City of Ketchum Planning & Building

PROJECT: Swan Stream Alteration/Bank Stabilization

PERMIT #: P18-131

REQUEST: Amendment to permit P18-131 issued October 19, 2019. Construction has not commenced. Permit remains valid under an administrative extension. Scope of work includes stream alteration, bank stabilization, land reclamation and restoration.

C.5 SECTION 105
 HORIZONTAL SCALE: 1" = 15'
 VERTICAL SCALE: 1" = 5'

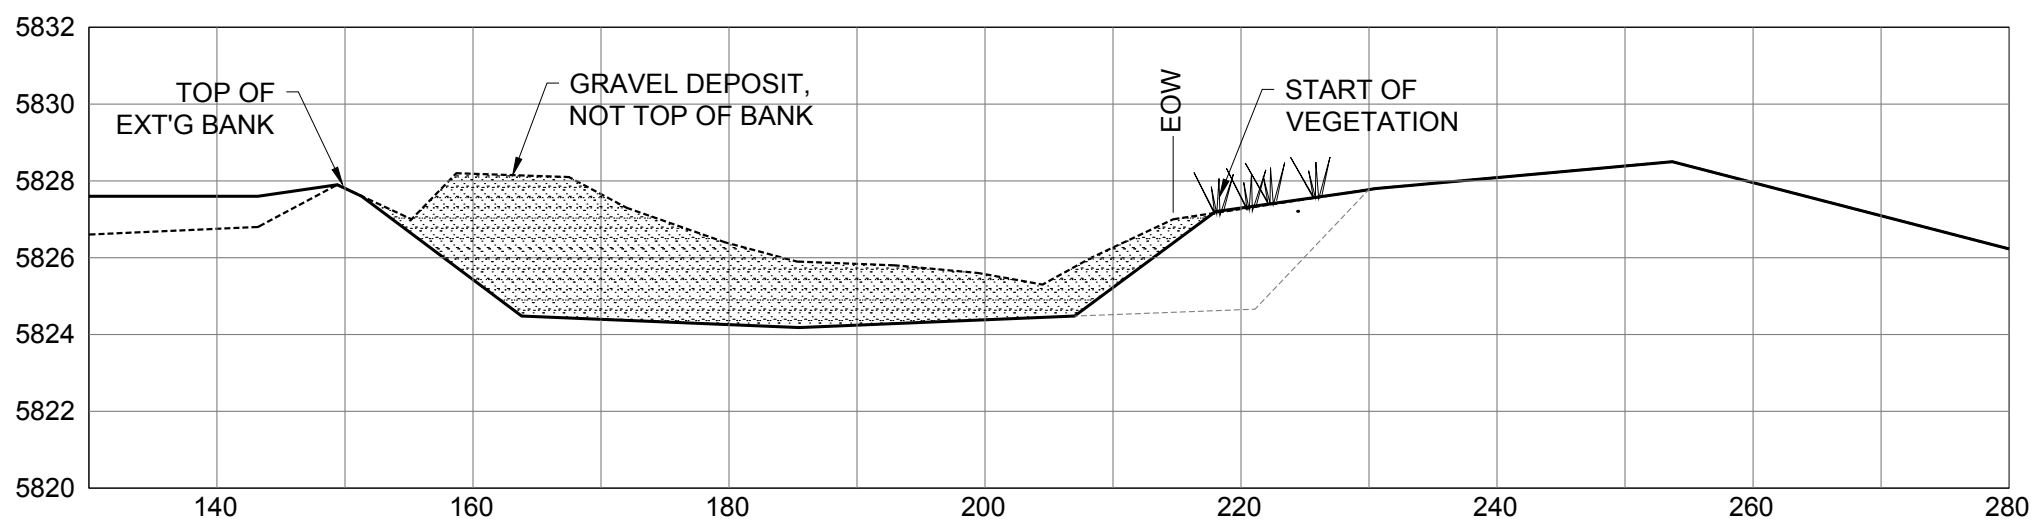
- The proposed amendment to the plans originally approved via P18-131 does not create a stable situation or permanent solution. The amendment to the project, as designed, increases velocity at Cross Section 105 at flows of 1,000 cfs. Velocity increase at lower, more frequent flows can cause erosion of unstable banks.
- Without bank stability components on 411 Northwood Way originally included in the project but proposed to be removed with this amendment, the elevation of the rock sill has been designed to promote bed erosion and downcutting of the channel upstream of the project onto the 411 Northwood Way property. This will cause the channel to create the hydraulic conditions included in the original design but without the previously proposed bank protection.

- The proposed amendment to the plans originally approved via P18-131 does not create a stable situation or permanent solution. The amendment to the project, as designed, increases velocity at Cross Section 105 at flows of 1,000 cfs. Velocity increase at lower, more frequent flows can cause erosion of unstable banks.

C.5 SECTION 105
 HORIZONTAL SCALE: 1" = 15'
 VERTICAL SCALE: 1" = 5'

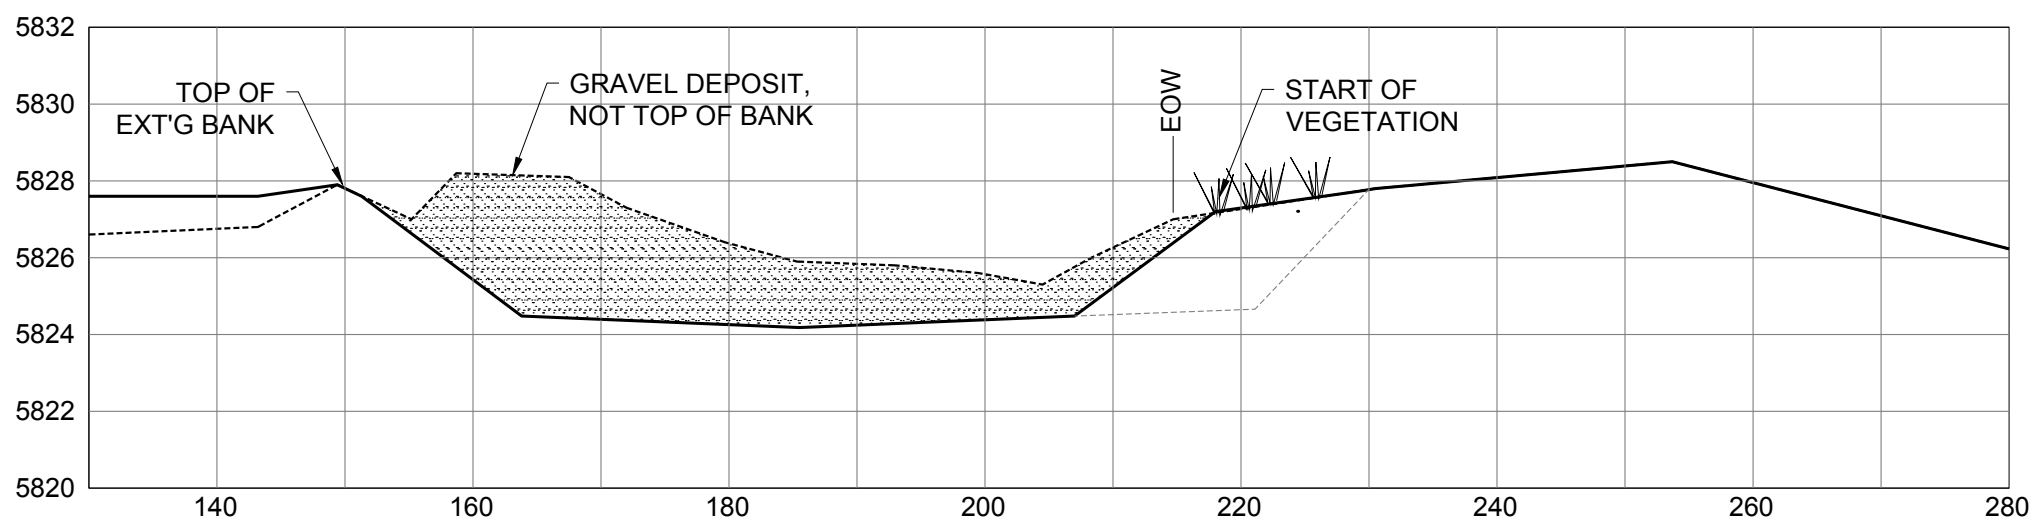
As depicted on the amended Drawings, the river channel excavation and grading work is now proposed to terminate just downstream of the shared Swan/Marsupial property line. This abrupt project transition will effectively create a vertical discontinuity in the river channel bottom between 18 and 30 inches in height over a horizontal length of approximately 15 to 25 feet as demonstrated by Sections 104 and 105 on Sheet 3 of the Amended Drawings. This resultant over-steepened section of river channel will be highly unstable and is expected to rapidly headcut upstream onto the Marsupial property. As the Amended Swan Project is no longer proposing to stabilize the approximately 60 feet of river bank through the transition section along the Marsupial property, the anticipated effect will be to further exacerbate the bank erosion issue already being experienced by Marsupial in this area as shown in Figure 1. The Amended Drawings do include a rock sill (Note 8, Sheet 3) that will serve to limit the height of the headcut to the previously mentioned 18 to 30 inches, but will not limit upstream headcut migration.

Based on our review, we request a denial of the Amended Swan Project until the concerns presented above have been addressed to the satisfaction of Marsupial, or both the Swan and Marsupial Projects have been coordinated to function as a single cohesive project that provides for long term channel stability and appropriate protections to the affected landowners.
